Safety Notice

Safety notice frontcontainer DROP - regarding all sizes

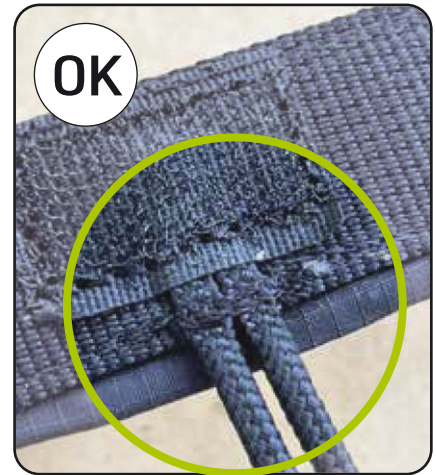
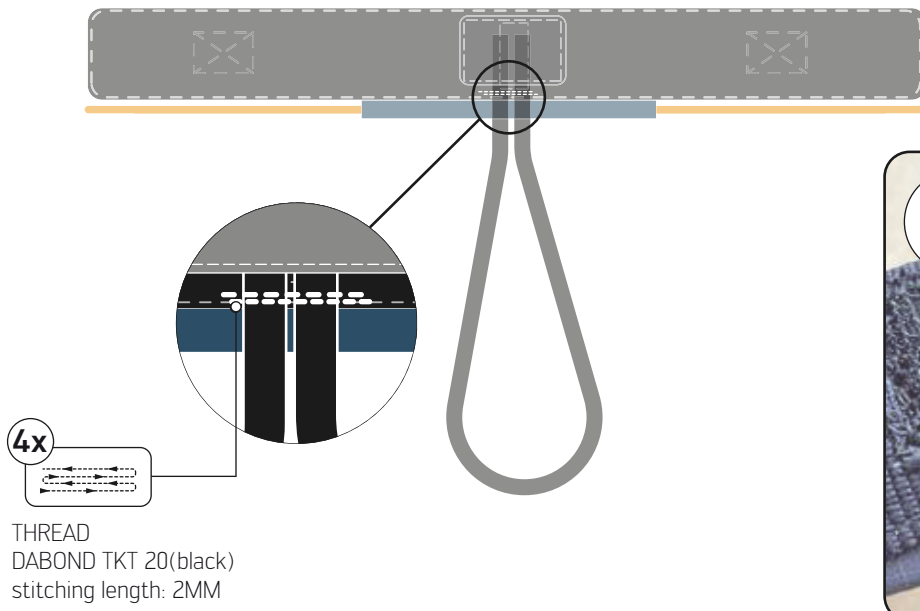
During our regular quality control, it was found on the DROP frontcontainer that the connection line leading to the rescue handle did not have the required seam strength. Our internal limit is 70DaN, which was undershot during quality control.

In order to rule out any safety risk, the DROP frontcontainer may only be used again after an additional fixing seam has been attached.
